**RESOLUTION SETTING HEARING ON APPEAL BY FAREWAY STORES, INC.
OF DENIAL OF SITE PLAN FOR PROPERTY LOCATED AT
2716 BEAVER AVENUE AND 2723 41ST PLACE**

WHEREAS, on June 3, 2021, the City Plan and Zoning Commission voted 7-3 to **DENY** a request from Fareway Stores, Inc. (owner), represented by Garrett Piklapp (officer), for approval of a Site Plan for property located at 2716 Beaver Avenue and 2723 41st Place, to allow redevelopment with a 7,759-square foot Storefront building type for Limited Retail Sales use and including Type 2 design alternatives to (1) allow one entrance fewer than the two required entrances on a primary frontage facade, calculated at one entrance per 45 feet of primary frontage required pursuant to Municipal Code Section 135-2.5.3.D.20, and (2) to allow 41% transparency on the ground floor of the primary frontage facade, which requires a minimum of 65% transparency pursuant to Municipal Code Sections 135-2.5.3.D.18 and 135-3.8.3; and

SITE PLANS FOR FAREWAY - BEAVERDALE

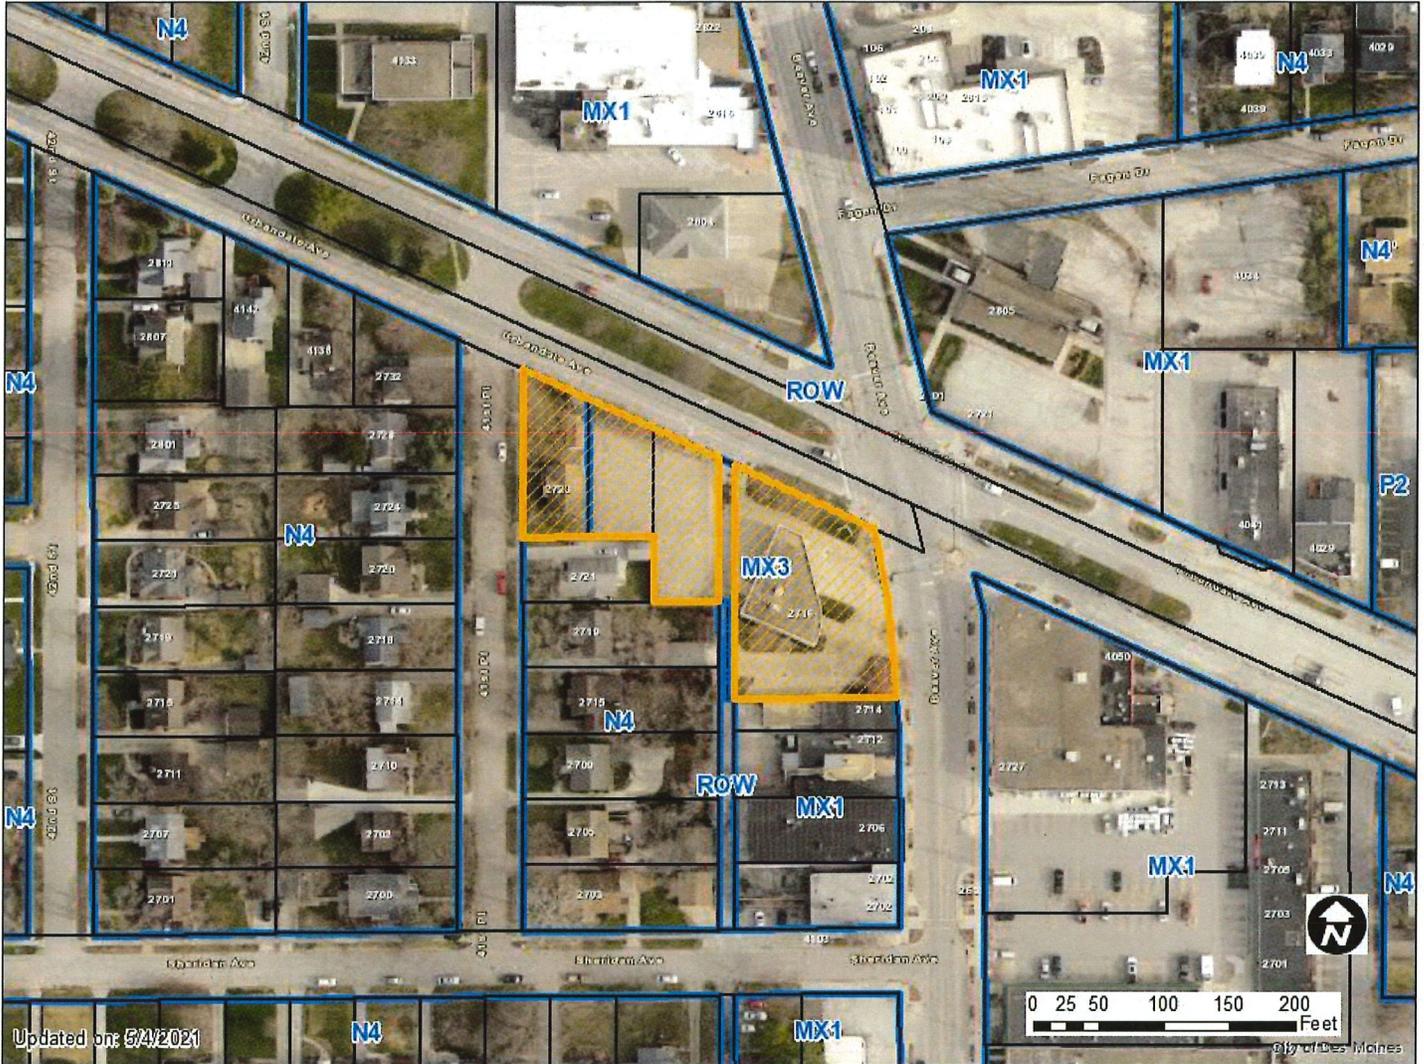
That said, I worry that the proposed site plan is neither inviting nor particularly accessible to pedestrian patrons of our commercial corridor, despite the applicant's repeated claims that the walkability of the Beavertdale business district is one of the features that most interested them in the site. I agree that walkability is one of the main assets of our neighborhood's commercial area, and I believe it is critical to our future as well. Indeed, the City of Des Moines, as well as other entities both public and private, spent considerable resources less than a decade ago on a streetscape project along Beaver Avenue to enhance and ensure the walkability of the area in perpetuity.

The shape of the site in question and the surrounding traffic patterns undoubtedly present some design challenges, to which I'm sympathetic. For instance, I understand the applicant's desire to have their main entrance face their parking lot, particularly after committing so much capital—financial and otherwise—to acquiring the scale of parking lot it appears they will have. And I don't doubt that this orientation means that including pedestrian access from Beaver Avenue presents challenges with regard to the interior floor plan of the business. But I also trust that the applicant has many talented and well-compensated people capable of meeting just such a challenge. I would also submit that this request—that there be prominent pedestrian access from Beaver Avenue—was utterly predictable, and the extent to which it wasn't foreseen by the applicant reflects a shortcoming in their design and public outreach processes rather than grounds for an exemption from zoning requirements with which they were surely familiar.

That a business in the heart of Beavertdale's business district should have prominent pedestrian access on Beaver Avenue seems to me so self-evident that I struggle to even articulate discrete reasons why. I trust that those of you familiar with the neighborhood will agree. So, at the risk of hyperbole, I think it will suffice to say that such an access is necessary both for the applicant to fulfill its long-stated commitment to build to suit the neighborhood, and also to avoid having its literal back turned toward the business community it seeks to join.

As regards the matter of ground floor transparency, while I'm certain that an unimpeded, behind-the-scenes view of the goings-on of a meat counter wouldn't be a highlight of the Beavertdale business district experience, incorporating enough translucency that passersby can at least sense the activity and bustle inside the business would add to the sense of vibrancy in the neighborhood's commercial area.

place, and which they have promised to maintain: walkability. I believe this can be done in three ways. First, as City Staff has recommended, incorporate a more prominent, two-way pedestrian access point on Beaver Avenue, to remain open during business hours. Second, and as City Staff has also recommended, use glass with a higher transmittance factor on the facades along both Beaver and Urbandale Avenues. And lastly, as some of the residents of 41st Place have requested, make the westernmost parking lot access exit-only to reduce points of conflict between vehicles and pedestrians.
